HILLPORT COMMERCIAL SUBDIVISION

Revised for the January 17th meeting:

APPLICATION NUMBER 18 DATE January 3, 2008

APPLICATION NUMBER 7 DATE January 17, 2008
 APPLICANT Hillport Commercial Subdivision
 REQUEST Subdivision

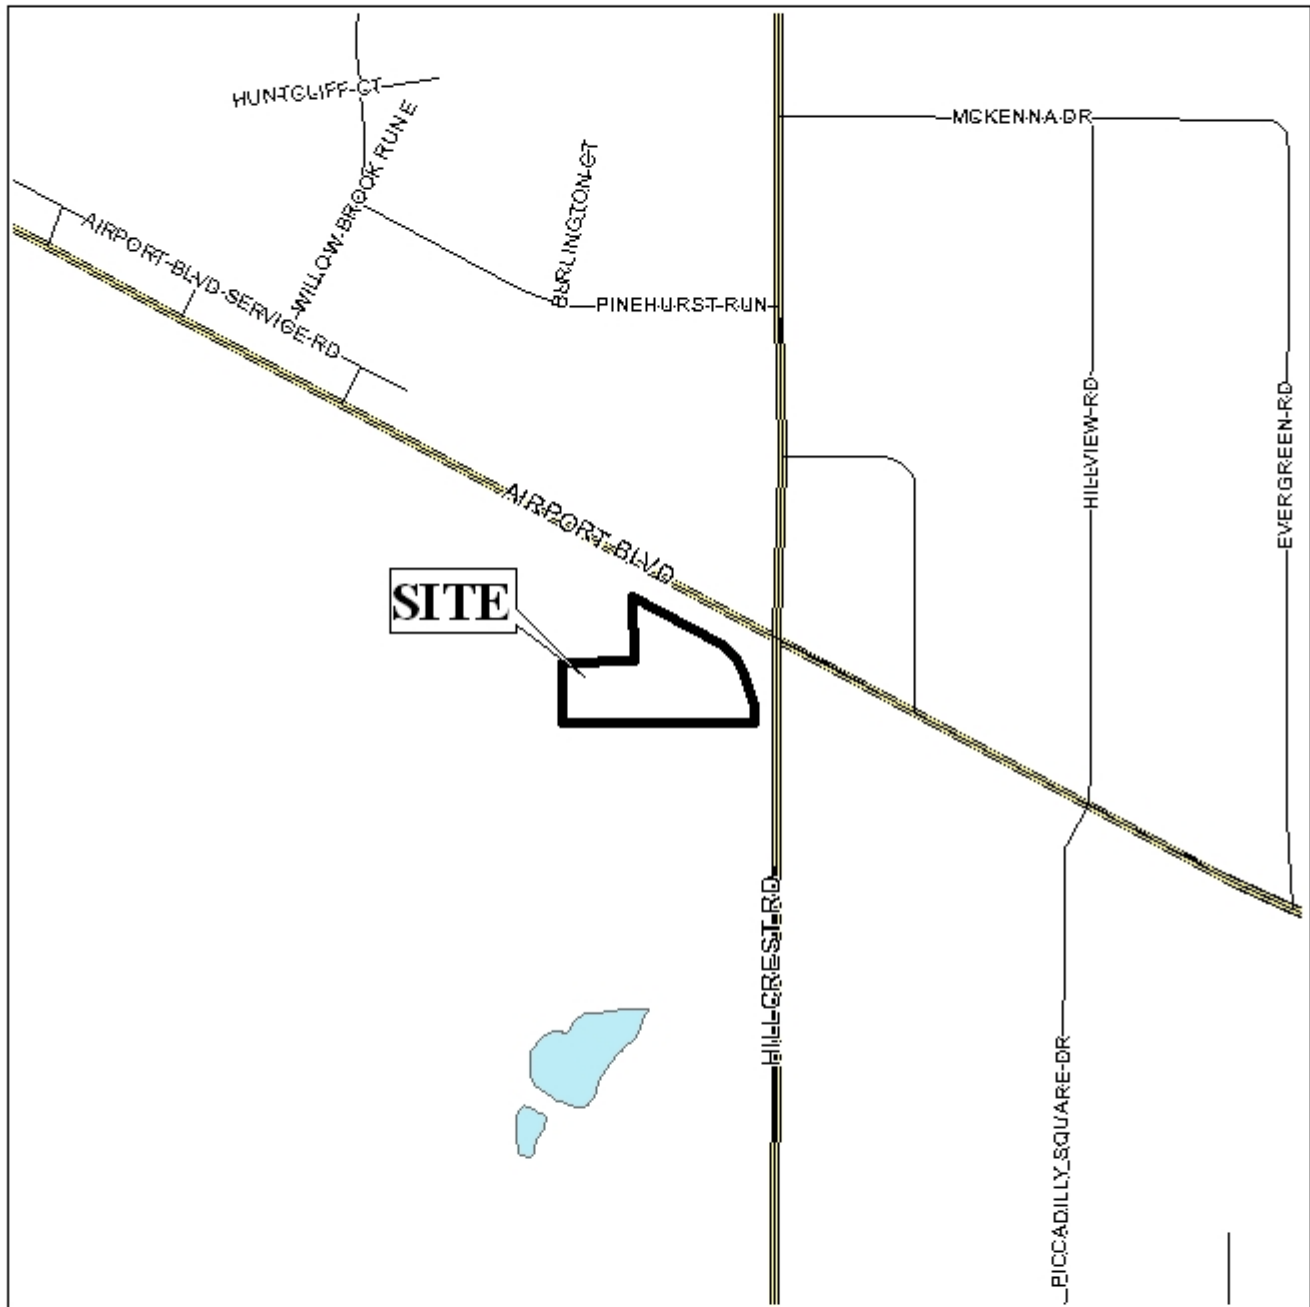
This application was held over to allow the applicant to submit a narrative explaining their request to modify the curb cuts of the subject site by the following:

- 1) *move the Airport Boulevard right-in-right-out curb cut to the far western edge of the property (away from the stoplight). This will help reduce traffic stacking both for entering and exiting the property via Airport. Also, since Airport has 60,000± VPD, moving the curb cut as far from the light as possible is desirable;*
- 2) *remove the sight obstructions on the part of the property fronting Hillcrest Road (i.e. the palm trees and parking spaces). Leave the Hillcrest frontage unobstructed to enhance safety; and*
- 3) *in return, allow an exit onto Hillcrest Road - this would effectively modify the right-in curb cut into a right-in-right-out curb cut on Hillcrest Road. Since Hillcrest has a traffic count closer to 30,000 VPD, the traffic congestion is cut in half compared to Airport Boulevard.*

Furthermore, the applicant proposes to deny the ability of a left turn onto Hillcrest Road, which appears to have a median at this location. To ensure this, the curb cut will be constructed in such a way as to force a right turn only, along with signage as needed or suggested by Traffic Engineering.

With regard to the applicant's request, since the site has an existing right-in curb cut from Hillcrest Road, the addition of a right-out curb cut would not further impede traffic to the property or street. Furthermore, since Hillcrest Road is not as busy a street as Airport Boulevard, creating another exit from the property may alleviate some of the traffic congestion onto Airport Boulevard.

Based on the preceding, this application is recommended for Tentative Approval, subject to the following conditions:

- 1) placement of a note on the final plat stating that the lot is limited to one curb cut to Airport Boulevard and one right-in-right-out curb cut to Hillcrest Road, with the size, location, and design to be approved by Traffic Engineering and conform to AASHTO standards;*

DETAIL SITE PLAN

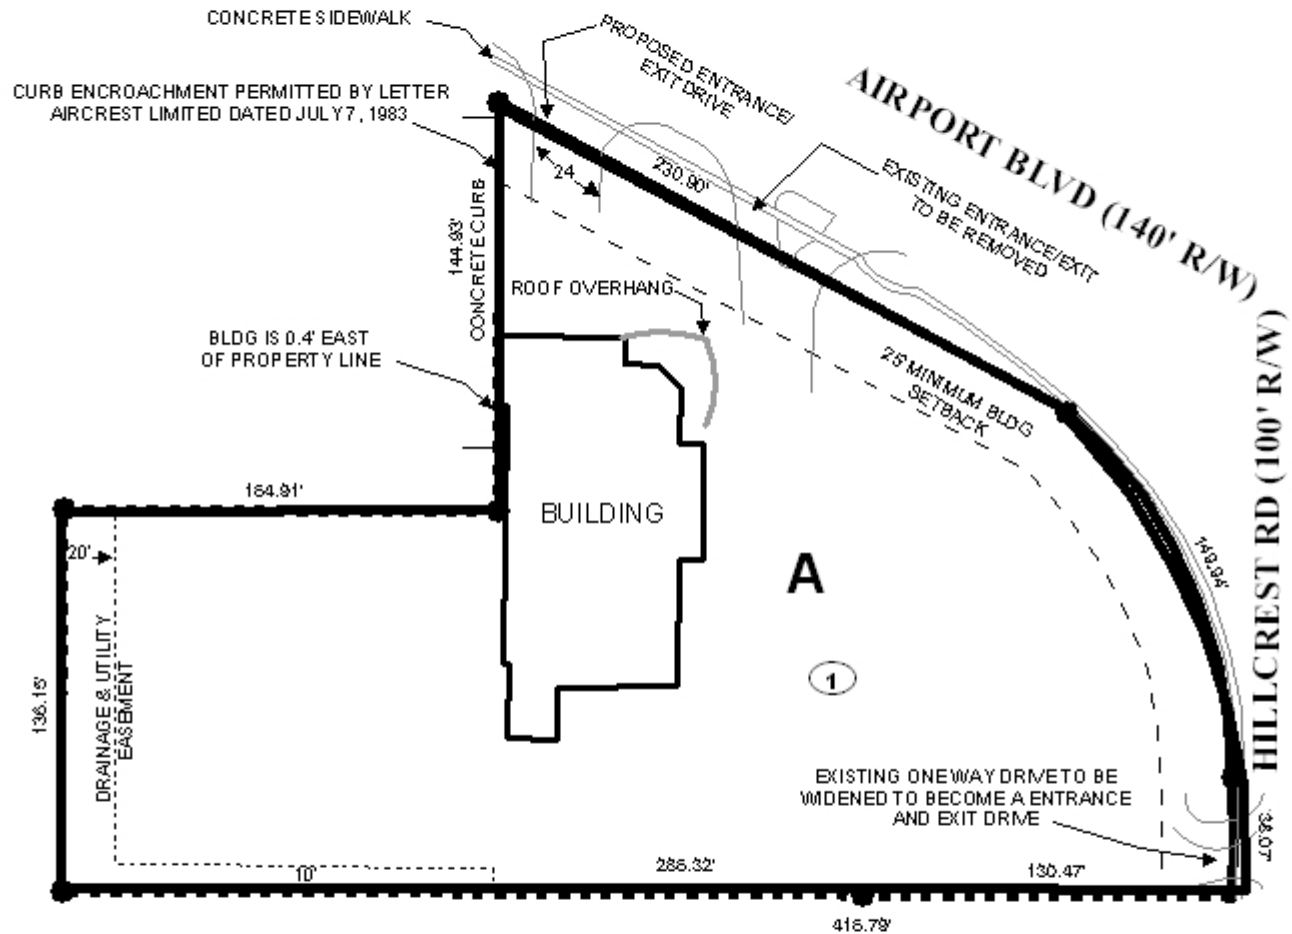
The plat meets the minimum size requirement for developments with access to public water and sewer. However, it is requested that the applicant revise the preliminary plat to label the lot with its size in square feet, or provide a table on the plat with the same information.

- 2) labeling of the lot with its size in square feet, or the provision of a table on the plat with the same information.*
- 3) subject to Engineering Comments: (Due to undersized downstream storm drainage system, any increase in impervious area will require 100-year detention. It is the responsibility of the applicant to look up the site in the City of Mobile (COM) GIS system and verify if NWI wetlands are depicted on the site. If the COM GIS shows wetlands on the site, it is the responsibility of the applicant to confirm or deny the existence of wetlands on-site. If wetlands are present, they should be depicted on plans and/or plat, and no work/disturbance can be performed without a permit from the Corps of Engineers. Must comply with all storm water and flood control ordinances. Any work performed in the right of way will require a right of way permit.)*
